**Project Details:**  
 Dalgise  
 Monkstown

**Drawing Title:**  
 Proposed Elevations + Section - Block E

Status	Purpose of Issue	Revision
P01	PLANNING PERMISSION	
MKS-RAU-E-ZZ-DR-AR-200		P02

Section 2-2  
1 : 200

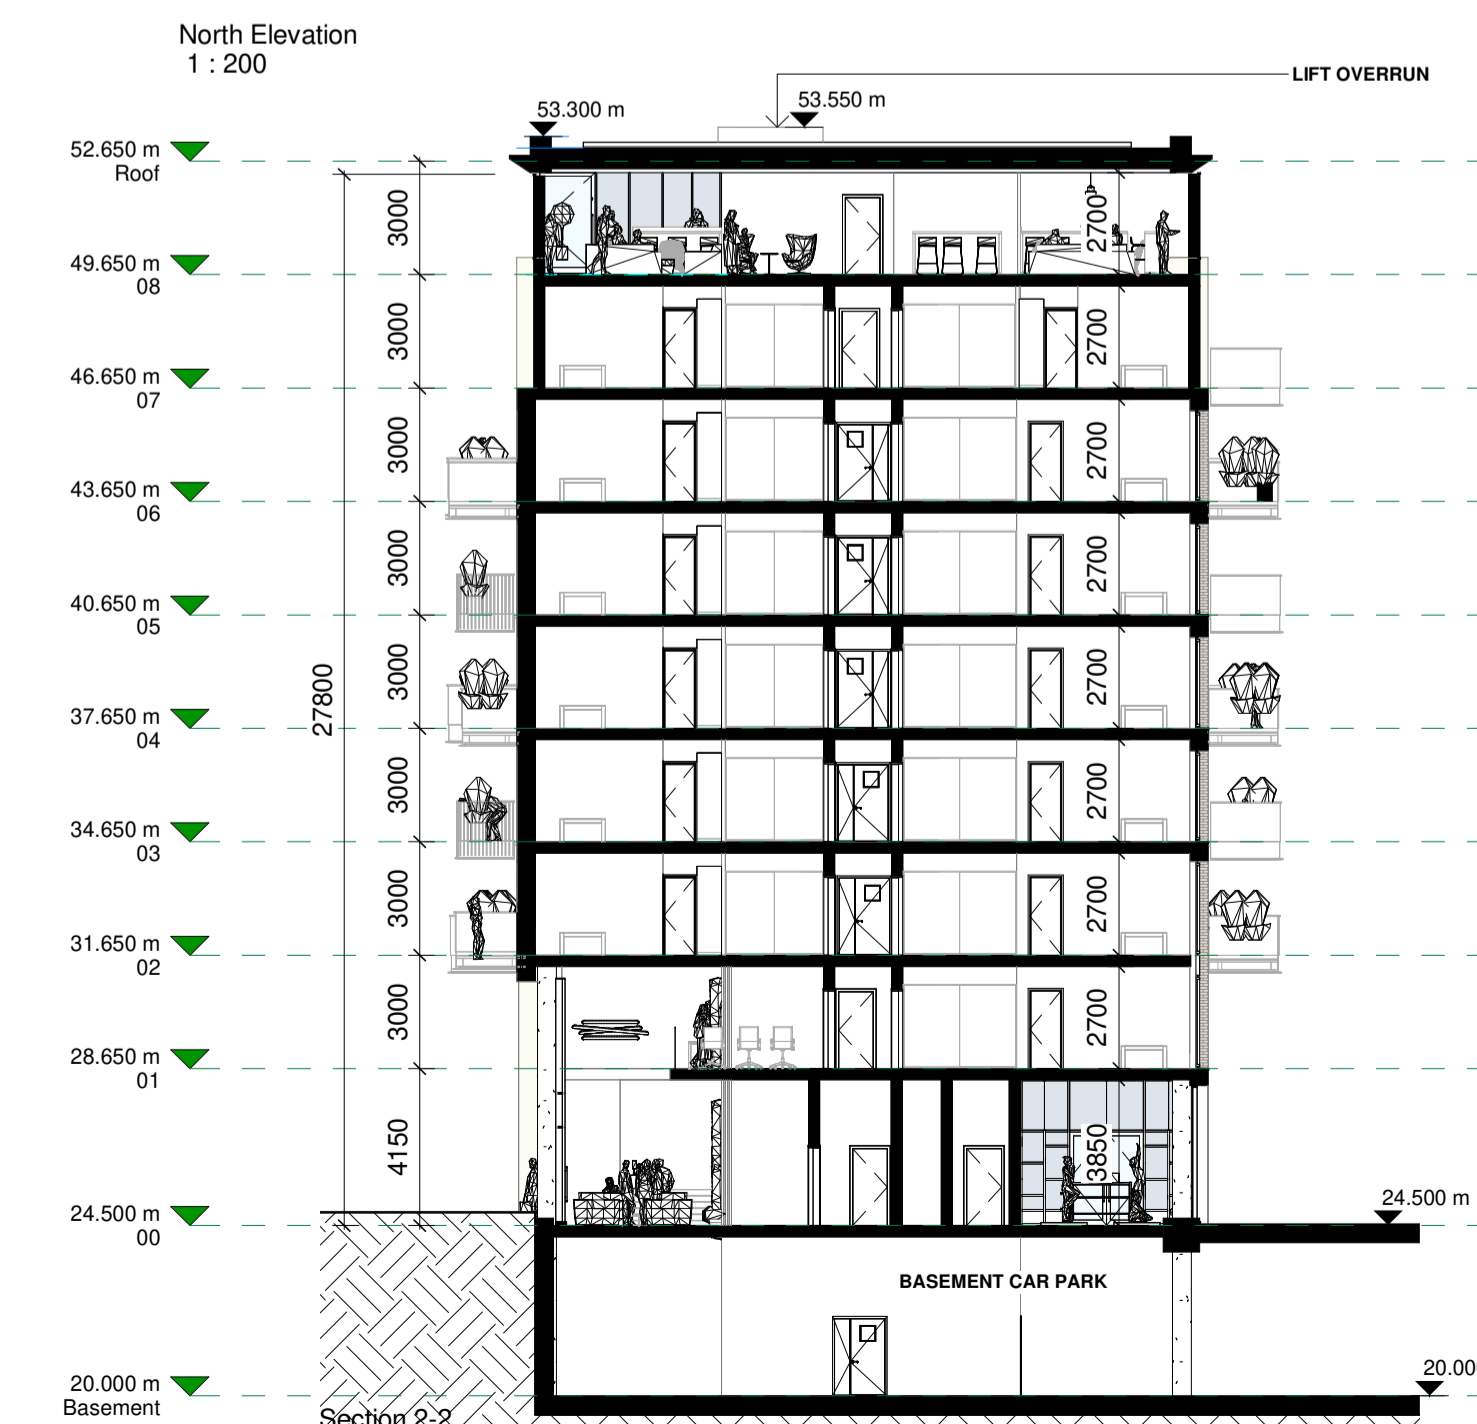
- REVISIONS**
- E1. Double Height Entrance Foyer, Mezzanine Floor with bookable rooms added.
  - E2. Glazing brought up extra level to first floor.
  - E3. Glass Shadow gap location and size revised.
  - E4. Tonal change at Penthouse Level and spandrel panels / balconies
  - E5. Steps to north of Block E omitted.
  - E6. Balcony positions altered from previous submission.
  - E7. Secure Bicycle Storage added and car parking re-configured.
